Planning Commission Minutes
August 8, 2024

STAFF REPORT
The City of Oklahoma City
Planning Commission
August 8, 2024

(SPUD-1655) Application by Raymond Jacobs to rezone 2820 North Robinson Avenue from R-4 General Residential, HL Historic Landmark and UC Urban Conservation Overlay Districts to SPUD-1655 Simplified Planned Unit Development, HL Historic Landmark and UC Urban Conservation Overlay Districts. Ward 2.

STAFF REPORT

CONCEPTUAL SITE PLAN

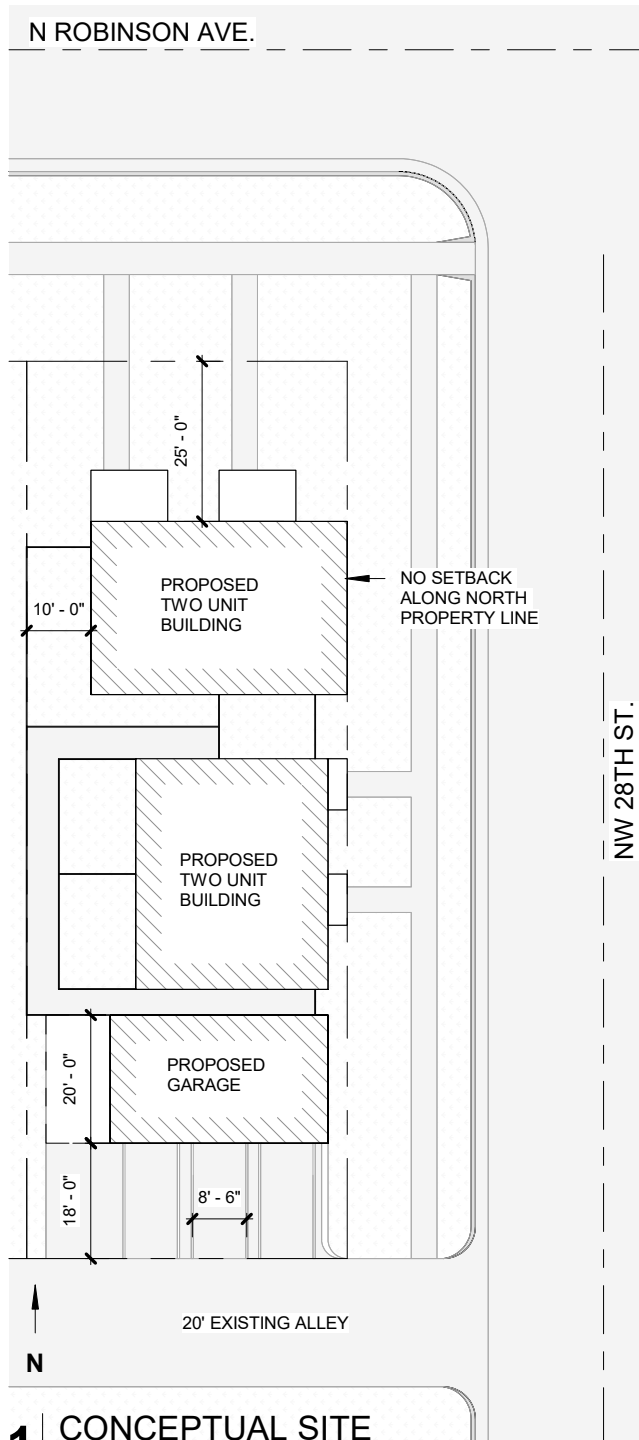
The subject site does not currently have any improved access. Remnants of paving are visible in the rear of the property. The SPUD proposes one drive along North Robinson Avenue and one drive from NW 28th Street; however, the conceptual plan illustrates the only access on the site would be for the proposed garage to take access from the 20' existing platted alley.

Sidewalks are currently available on the subject site, along North Robinson Avenue. The SPUD regulations require sidewalks along both frontages and the conceptual plan illustrates sidewalks with paving leading to both units in each residential building.

The SPUD is requested to allow multi-family residential development with R-4 base zoning and HL and UC overlay zoning and a maximum of four dwelling units. The SPUD site plan contemplates the development of two detached duplexes and a detached garage with a carport. The SPUD proposes limiting the number of buildings to two main structures and one detached garage. The SPUD proposes a maximum building height of 2.5 stories and 35 feet. Zero-foot setbacks are proposed for the east (adjacent to the alley) and north (adjacent to NW 28th Street), as well as between internal lots. NW 28th Street has an 80-foot-wide right-of-way adjacent to the site, with approximately 25 feet of yard between the curblin and property line. No conformance issues were identified.
